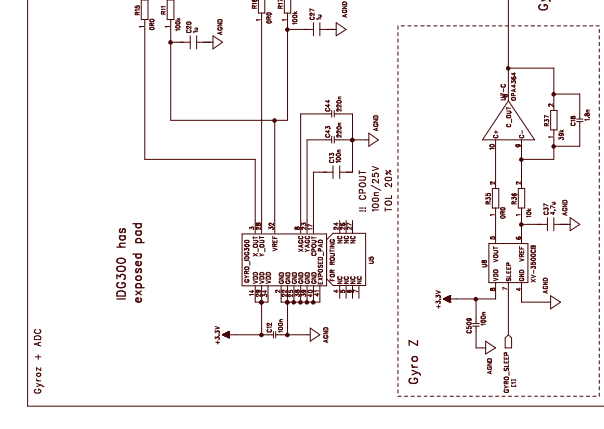
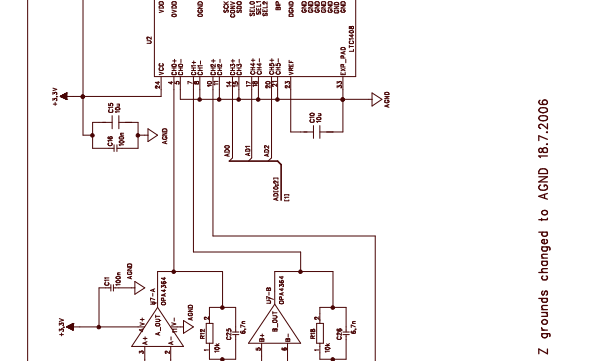
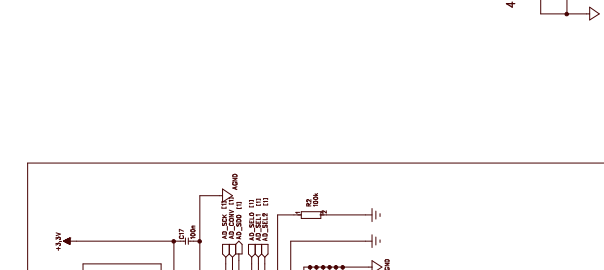
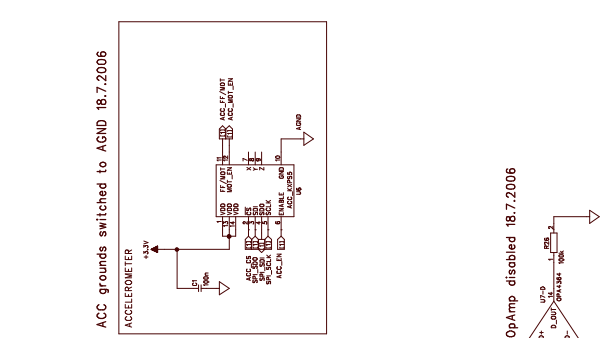
Reset moved 30.6.2006  
 PLD33\_R16 added 30.6.2006  
 PLD33\_R10:191 --> PLD33\_R10:161 30.6.2006

Try to isolate  
 VCCA from VCCD / VCCINT  
 as well as possible  
 Place caps between  
 VCCA and GND

Left side connector  
 Pins are mirrored!

All banks are 3.3V  
 Add more bypass capacitors  
 if needed for routing etc.

Right side connector  
 Pins are mirrored!
